**R66 SERVICE BULLETIN SB-15**

**SUBJECT:** G500H Wire Chafe

**BACKGROUND:** RHC has received a report of the annunciator panel wiring chafing against the Garmin G500H's GDU 620 display. This bulletin requires installing wire protection in the affected area.

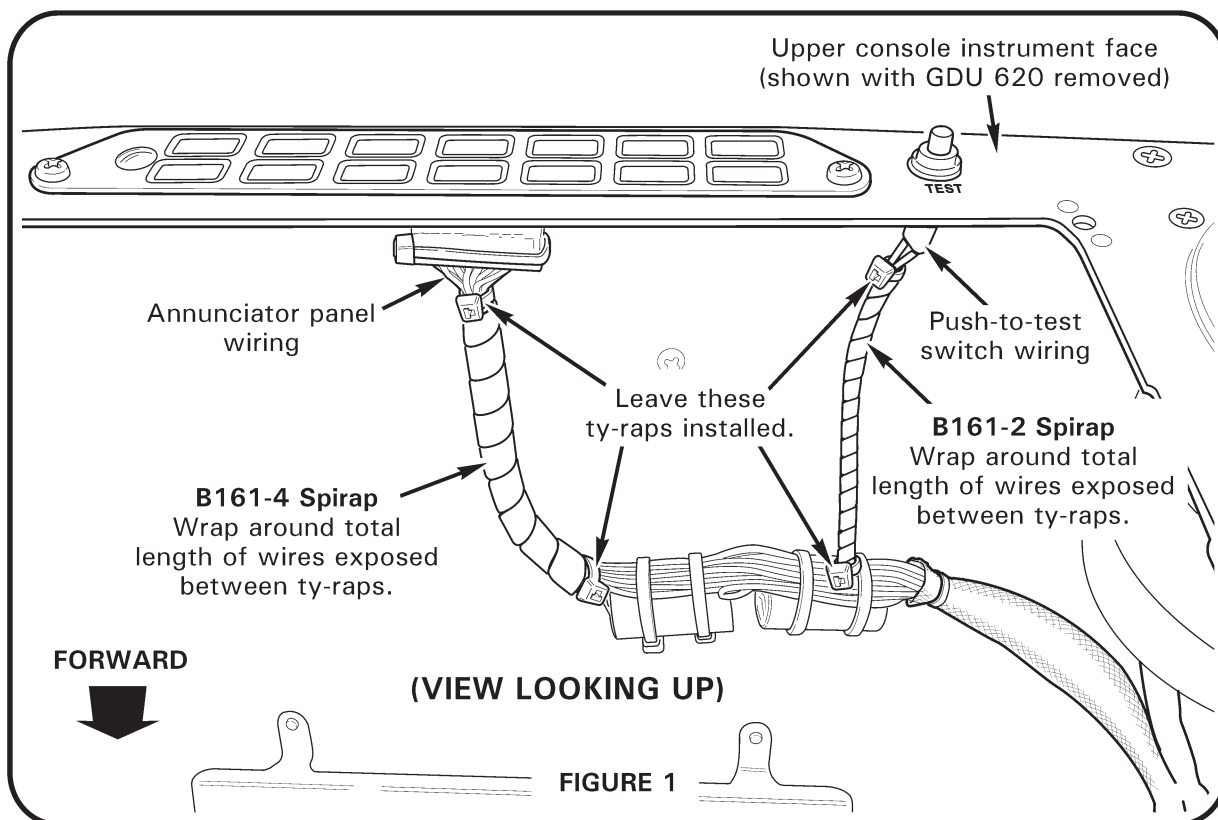
4. Refer to Figure 1. Cut and discard ty-rap(s) as required, and install B161-4 spirap over annunciator panel wiring, and B161-2 spirap over push-to-test wiring at locations shown. Verify spirap coils are tight but do not overlap; trim as required.

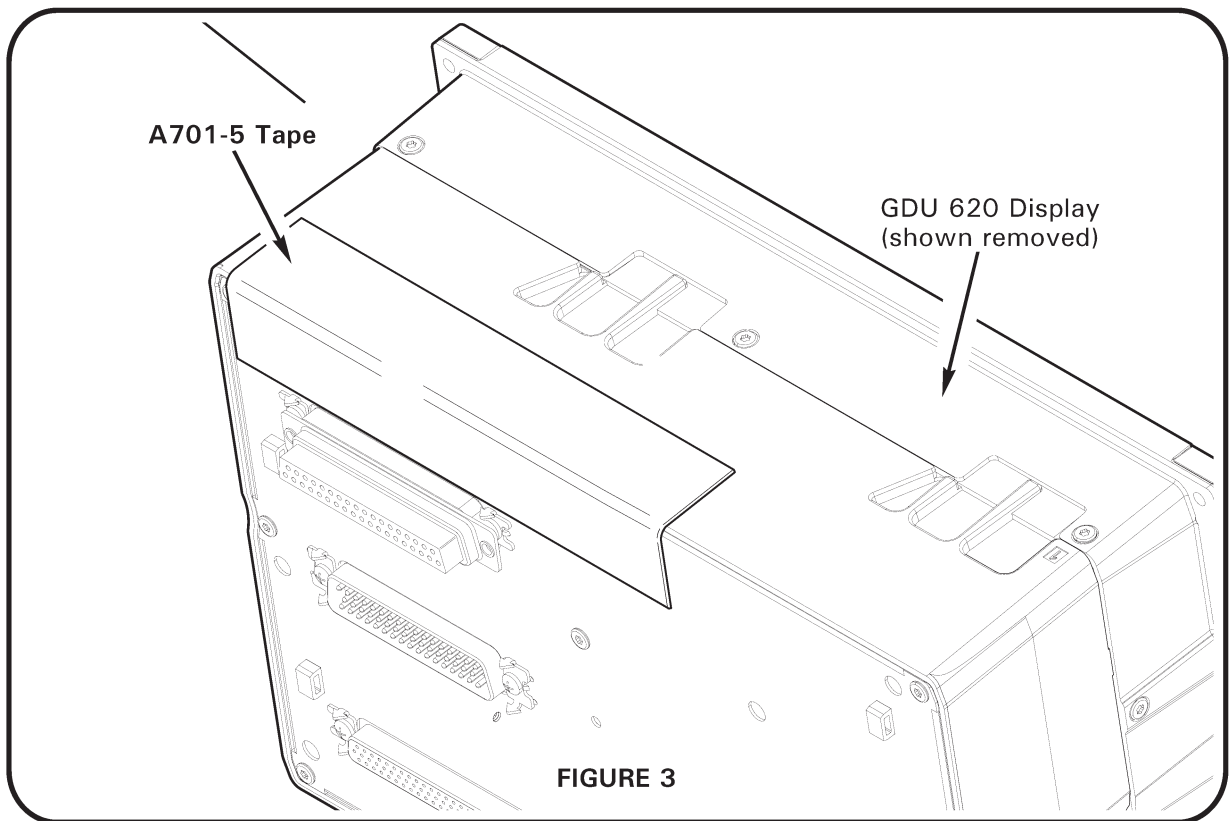
5. Refer to Figure 2. Noted strain-relief ty-rap must remain. Cut and discard ty-raps as required and reposition instrument cluster wiring to provide clearance from installed display. Install MS3367 ty-raps as required. Cinch ty-raps until snug without overtightening and trim tips flush with heads.

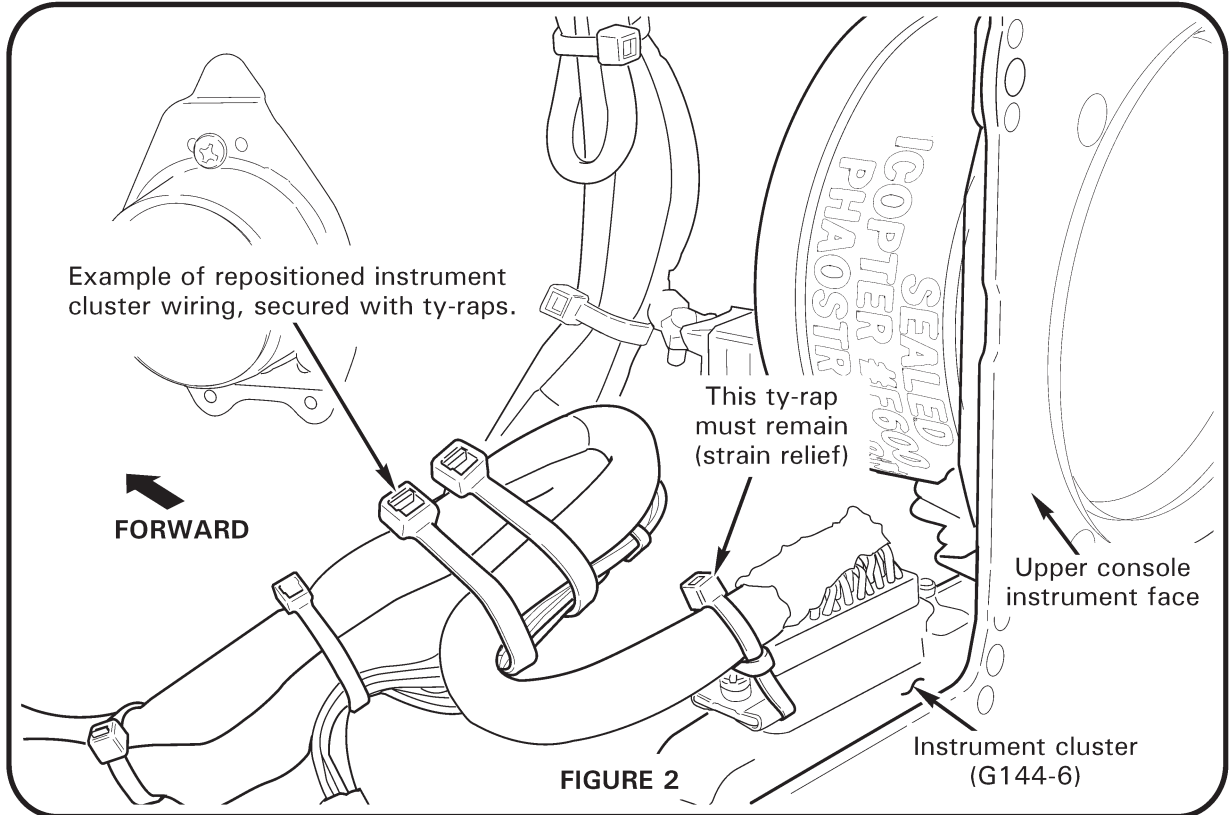
6. Refer to Figure 3. Fold A701-5 tape in half lengthwise toward adhesive-side. Install tape on display as shown.
7. Install GDU 620 display per MM § 95-71.
